From: "MILLER, D BRYAN" <dmill14@entergy.com>
To: "N. Kaly Kalyanam" <nxxk@nrc.gov>
Date: Wed, Jul 26, 2000 4:32 PM
Subject: DRAFT - EFW RAI Response

Response to Request for Additional Information Related to
Technical Specification Change Request NPF-38-206
Regarding the Emergency Feedwater System

Reference: Enclosure Two to Waterford 3 letter dated January 31, 2000. Technical Specification Change Request NPF-38-206, Revision1.

DRAFT**FIGURE 1 - Time Charts for Steam Generator Fill****Time Chart 1 - Steam Generator Fill with SG Pressure = 200psig****Time Chart 2 - Steam Generator Fill with SG Pressure = 1000psig**

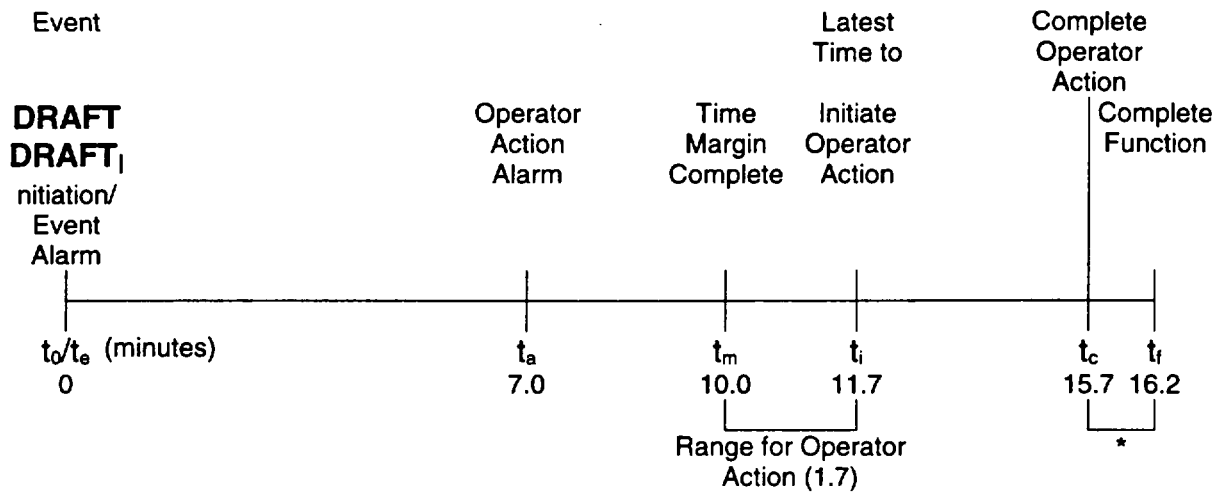
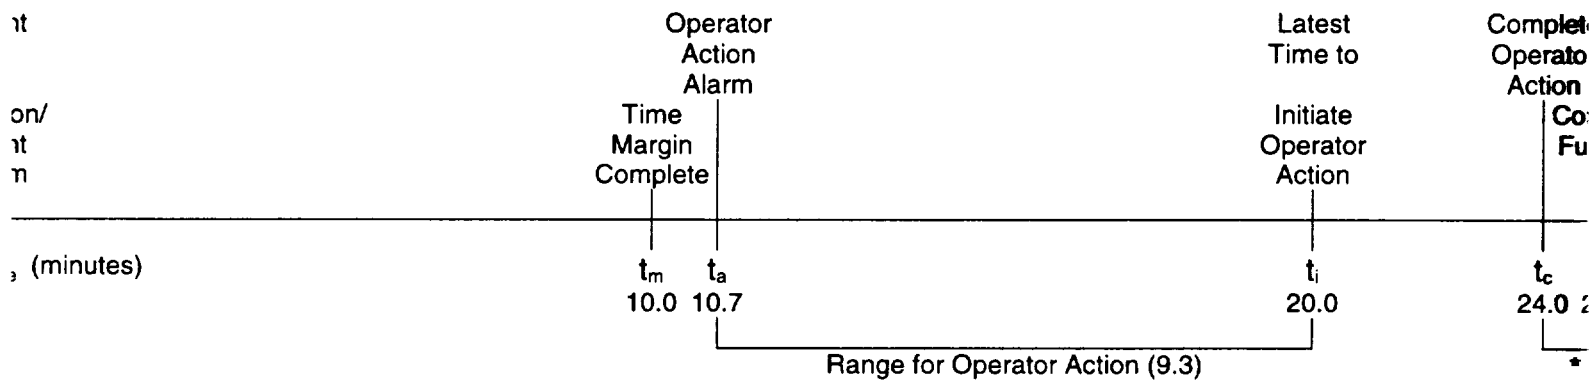
- a. What is the meaning of "greater" in "greater than 13 minutes?" - how much greater than 13 minutes?
- b. American National Standards Institute/American Nuclear Society (ANSI/ANS Standard ANSI/ANS-58.8-1984 shows a minimum of 10 minutes for Time Test #1 (Plant Condition 3, Loss of Off-site Power (LOOP)). Added to that would be a minimum of four minutes for Time Test #2 (PC 3, LOOP, one manipulation). Added to that would be one minute per additional operator manipulation. Added to that would be equipment process time. Assuming only one manipulation and no equipment process time, the result is already at 14 minutes. Please explain how you arrived at a time delay of from two to six minutes using the referenced standard.

Please provide a time criteria in accordance with the provisions of ANSI/ANS-58.8-1984 with the maximum EFW flow of 2300 gallons per minute to a single steam generator

The revised values for operator action time calculated from the re-evaluation of SG fill rates (see Response 1.a above) have been compared to the recommendations of ANSI/ANS-58.8-1984 and are provided in Figure 1. This comparison is based on one operator action in the control room to close the open isolation valve. An equipment process delay time of 30 seconds for the isolation valve to close is conservatively used.

Figure 1 provides a comparison to ANSI/ANS-58.8-1984 Figure 2 for the highest SG fill rate at 200 psig and the SG fill rate that is associated with 1000 psig. The Range for Operator Actions for these two cases is 1.7 minutes and 9.3 minutes, respectively. The figure shows that the guidelines in the ANSI/ANS standard are met. Accordingly, the times allow credit for manual operator action in these events.

This scenario has been replaced by the re-evaluation described in Response 1 above. The EFW flow rate was dependent on the SG pressure. The EFW flow rate used at the pressure that resulted in the shortest time to overfill was 2536 gpm. A comparison to the time criteria of ANS/ANS-58-8-1984 for the re-evaluated SG fill rates is provided as part of Response 1.
